Determination 2017/074

Regarding the requirement for fire resistance of a timber structure at 2 Ada Street, Remuera, Auckland

Summary

Figure 1: Elevation indicating approx. siting to relevant boundary and adjacent dwelling (not to scale)

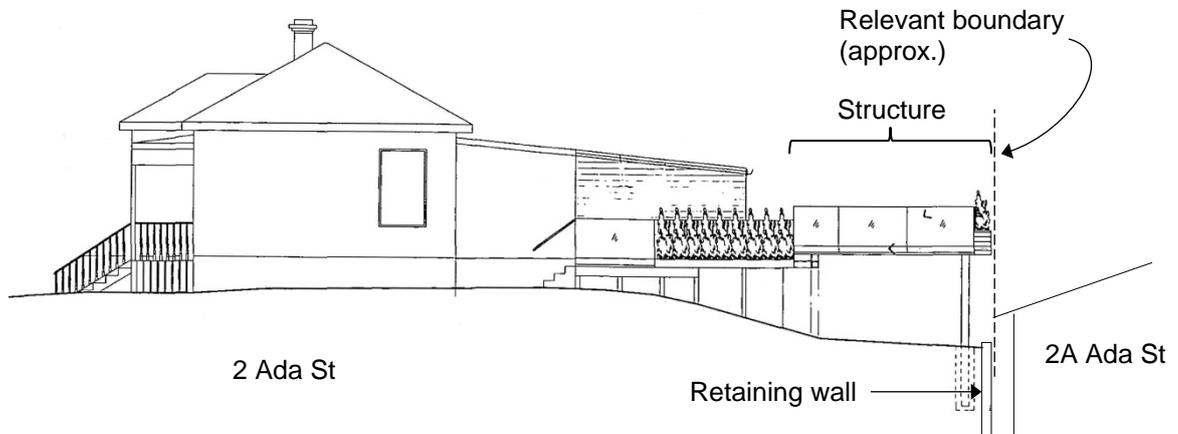
- The new structure is 59m² and within 100mm horizontal distance to the applicant's house; the boundary between the properties is at the end of the eaves of the applicant's garage.

- There is potential for fire to spread from the structure to the applicant's house because the structure is cantilevered over and sits beside the garage.

Figure 2: Site plan (not to scale)

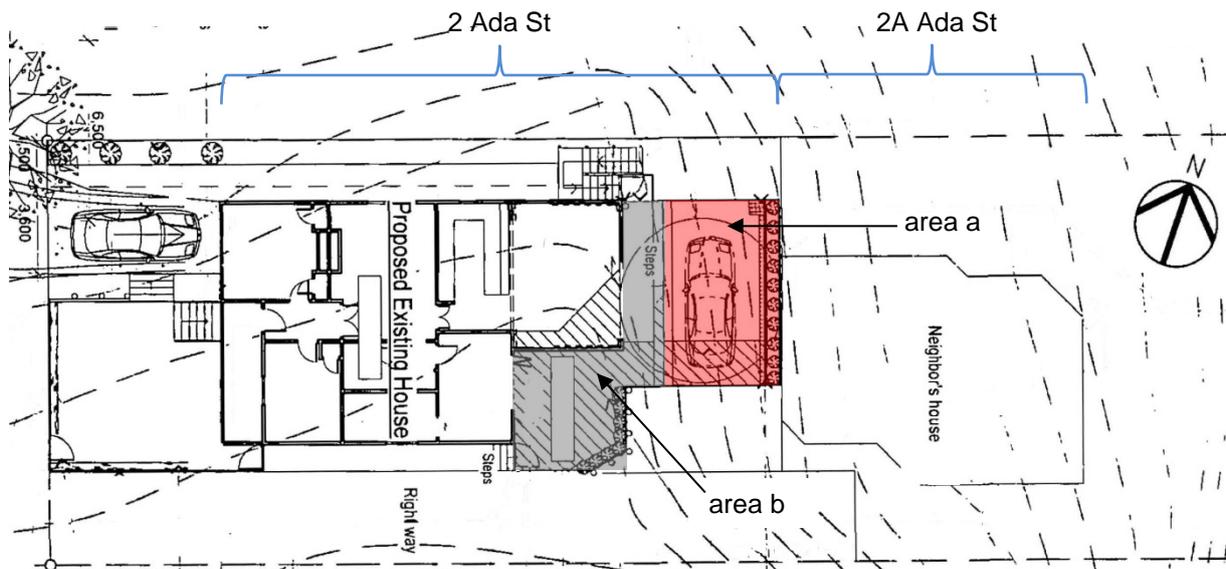
- 5.2.14 The applicant is of the view that the structure's area is 59m². However, Area B (see Figure 2) should not be included in the calculation of the area for the purpose of C/AS1 5.5(c); it is only the area where the fire load, such as a vehicle or storage, could be present and forms the hazard that is calculated (in this case Area A). Based on the plans I calculate this area to be less than 40m² and this satisfies the first part of the third criterion.

- 5.2.15 The applicant has stated that the structure is 'within 100mm horizontal distance to [the applicant's] house'. As noted earlier in this determination, I have not received a current survey plan that would provide accurate information on the relative locations of the as-built structure, the boundary, and the applicant's garage. However, it appears from the consented site plan and the images provided that the edge of the structure is closer than 0.3m to the relevant boundary.

- 5.2.17 I note that should adequate separation distance be provided from the structure to the relevant boundary, this would satisfy the third criterion of paragraph 5.5. C/AS1 would then be satisfied and fire rating would not be required. Although, any proposed amendment to the building consent should be presented to the authority for its approval.
